Signa® Images / Artifacts

SN 67038

DWEPI ARTIFACTS DUE TO GRADIENT COIL MECHANICAL ROCKING

GRADIENT ISOLATION KIT REPLACED THE HARD MOUNTED COIL SUPPORT
ILLUSTRATION 2

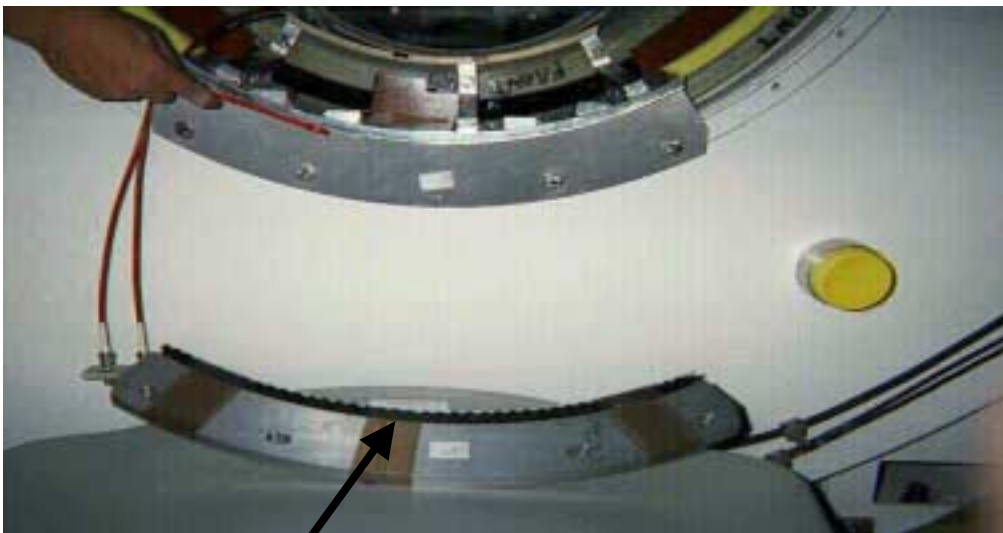
The following illustrations show the change in parts between the original product configuration and the change to the gradient isolation kit.

Gradient Isolation Kit – consisting of a low profile coil support bracket and a matrix isolation material.

END VIEW OF MAGNET W/ GRADIENT ISOLATION & UPPER RADIAL SUPPORTS
ILLUSTRATION 7

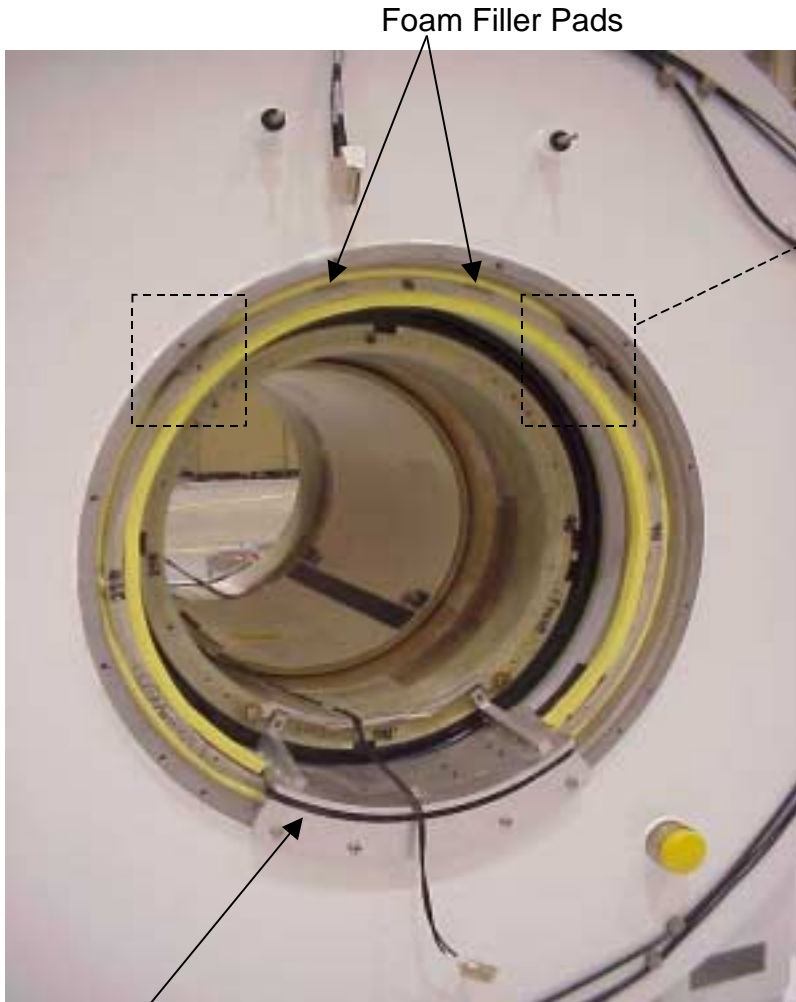
To resolve the gradient coil support issue, two (2) upper radial support members will be added to each end of the gradient coil. The radial supports consist of an M16 bolts and phenolic pads with a thin rubber backing. The M16 bolts thread into the end flange of the gradient coil radially outward. The phenolic pad will be pressed against the magnet warm bore as the bolt is threaded towards the magnet warm bore. The radial locations are at the 2 o'clock and 10 o'clock positions. Placing the supports at the positions will provide the gradient coil a lateral or side to side support and vertical or up and down support. Refer to Illustration 7 to understand the parts supplied with this kit (R4391JA for BRM's and R4391JB for CRM's) and Illustration 8 for an enlarged view of a properly install upper radial support.

- 1) Install foam filler pads, part number 2181231-2 in top 2 pockets on gradient OD (outer diameter), see Illustration 7.
This is done in 2 locations of the gradient coil, both the front and back.
- 2) Pull out 1/2" black rubber cord from between gradient and magnet bore down to the gradient support bracket.
- 3) Cut the rubber cord 3" (inches) past each side of the gradient support bracket and push the tails back in.
- 4) Insert the yellow or pink foam seal; part number 2174929-9 between the gradient and magnet bore, overlapping the remaining rubber cord at the bottom to form a good air seal.
- 5) Replace rubber cord on opposite end in same manner.
- 6) For BRM install cap screw part number 2108933-2 in the 2 positions indicated in Illustration 7. These will be installed at both ends of the gradient coil

For CRM install cap screw part number 2131956-2 in the 2 positions indicated in Illustration 7. These will be installed at both ends of the gradient coil
- 7) For BRM install Bearing shim part number 2212715-2 with rubber against magnet ID (inner diameter) as shown in Illustration 8.

ILLUSTRATION 8

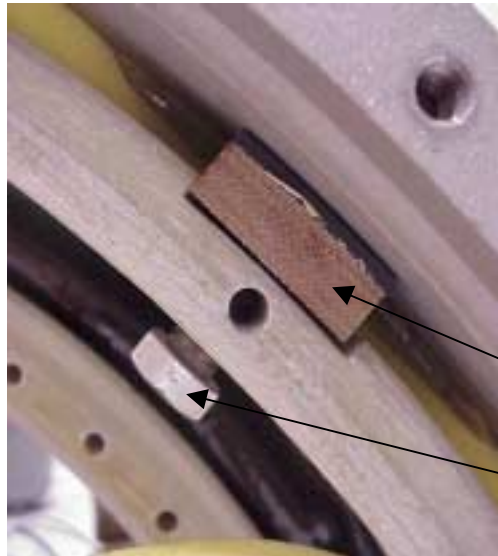
Cap Screw
- Torque 1/4 turn past snug

For CRM install Bearing shim part number 2131953-4 with rubber against magnet ID (inner diameter) as shown in Illustration 8.
- 8) Tighten screws until snug (bearing shim doesn't move).
- 9) Then torque each screw 1/4 turn past snug.
